Panel Report

Melton Planning Scheme Amendment C173

**Melton Landscapes - Significant Landscape Features
Strategy 2016**

30 April 2018

Figure 4 Mt Kororoit SLO

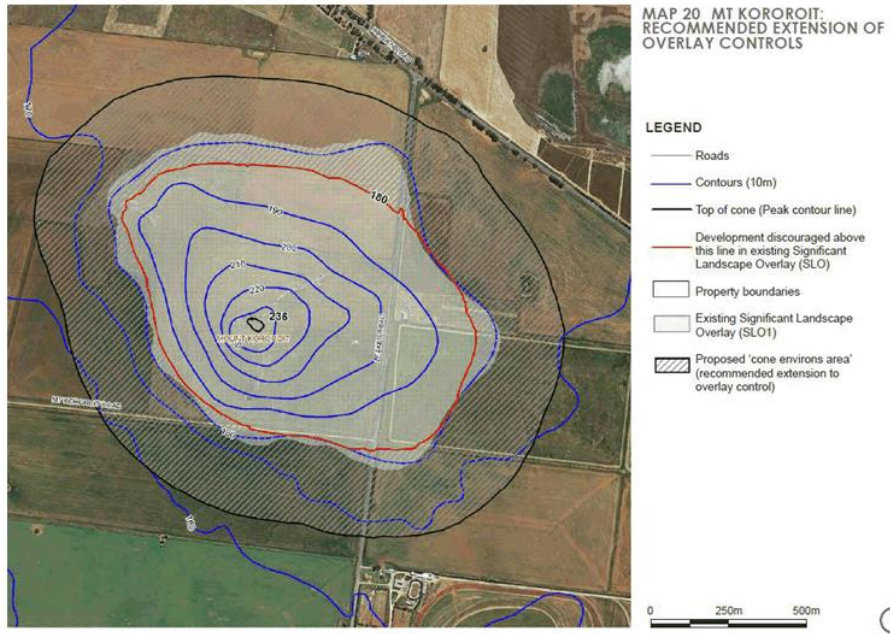
incorporate a buffer (or environs area). The Rosengren work in the 1980s uses the 170 metre contour (not 160 metres as used by Planisphere) for Mt Cottrell. For Mt Kororoit the Rosengren work does not align with a contour but it seems the Rosengren mapping indicates an area smaller than the current SLO.

Council provided further clarity to the SLO mapping, in response to a Panel Direction. This Direction noted there were two different reference points (for example, for Mt Cottrell it refers to both the 160 metre contour and the existing SLO boundary) in the SLF Strategy from which the cone environs area was to be based. Figures 2, 3 and 4 indicate these are not the same. Council advised:

The Panel has supported drafting improvements to some of the planning controls. Prior to approval of the Amendment, Council should ensure the mapping of the SLO that reflects the cone environs area is based upon the relevant contour for Mt Cottrell and Mt Kororoit.

- As discussed at the Panel hearing, the existing SLO mapping was understood to reflect the relevant contour. However, with the benefit of modern LIDAR data, it has become apparent that the existing SLO area does not correspond with the actual AHD contours (Mt Kororoit 180m; Mt Cottrell 160m).
- Reference in the SLF Strategy to distances measured ‘from the base of the cone area (i.e. existing SLO Boundary)’ (Figure 1), and ‘from the core cone area (i.e. existing SLO boundary)’ (Figure 2) were intended as references to the actual AHD contour of the base of the cones (Mt Kororoit 180m; Mt Cottrell 160m).
- The proposed extent of the SLO is calculated using the formula set out in Figures 1 and 2 of the SLF Strategy. The relevant extent is measured from the relevant AHD contour (Mt Kororoit 180m; Mt Cottrell 160m).

Council advised the red line on Figures 2, 3 and 4 represent the relevant contour as derived from ‘best available’ LIDAR data. Council confirmed the reference to “existing SLO boundary” is not accurate.

Figure 5 Mt Cottrell SLO

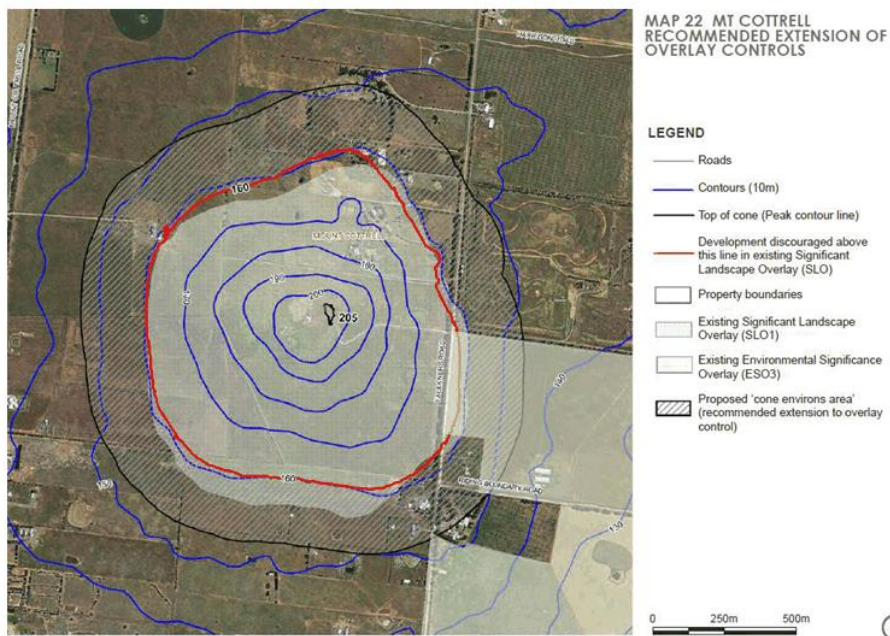
Mr Spehar questioned the reference point for the SLO boundary mapping for Mt Cottrell. He noted that, either the current SLO1 is mapped incorrectly as it extends beyond the relevant contour (that is, 160 metres for Mt Cottrell) or it includes a buffer already and there is no need for an extended cone environs area. If the former were true, then the cone environs areas would be reduced in size and not affect his father's property. This led to the Panel issuing a further Direction. Council's response is provided in Chapter 1.2.

Figure 6 Mt Atkinson SLO

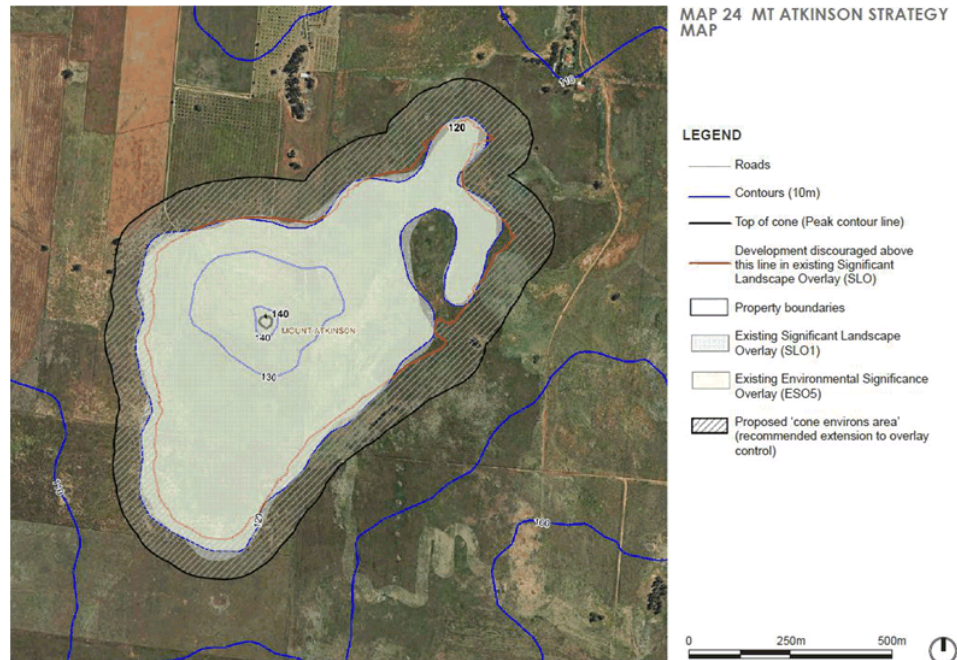
Council advised the Panel prior to the Hearing that it sought to abandon the proposed SLO extension for Mount Atkinson as it:

... has considered the Mt Atkinson related submissions in light of the approved Precinct Structure Plan (an event that occurred after finalisation of the Amendment documentation and at a time when the Amendment was too advanced to change the documentation). In the circumstances Council advises the Panel that it does not intend to peruse at Panel the mapping changes to the Significant Landscape Overlay for Mt Atkinson.

Council now proposes that the existing mapping of the Significant Landscape Overlay continue to apply to Mt Atkinson. This is outside of the approved limits of residential development and ensures consistency between the Precinct Structure Plan objectives and the application of the SLO.¹

Mount Atkinson Holdings and Stockland Development own land affected by the Mt Atkinson SLO mapping and withdrew from the Hearing based on Council's decision to abandon the Mt Atkinson mapping and to retain its current application. Figure 7 indicates the type of urban development expected around Mt Atkinson from Amendment C162 which approved the Mt Atkinson and Tarneit Plains Precinct Structure Plan on 12 September 2017.

The Panel supports the deletion of the Mount Atkinson SLO mapping from the Amendment as it would have applied a control that was inconsistent with the approved future urban land use and form. This report therefore considers the balance of the Amendment.

- 1. Abandon the proposed extension of the Significant Landscape Overlay at Mt Atkinson.**

Figure 8 Council owned land at Mt Cottrell

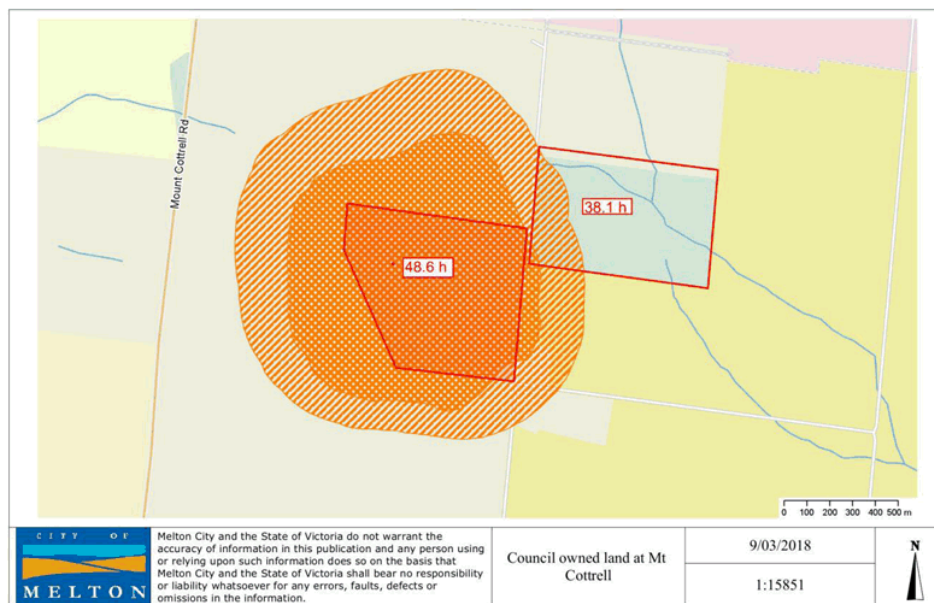
- *Confirm what land Council owns at Mt Cottrell.*

- Council owns land identified in Figure 8 at Mt Cottrell.
- Council was unable to find any materials that supported the use of the 160 metre contour for the SLO at Mt Cottrell. It submitted:
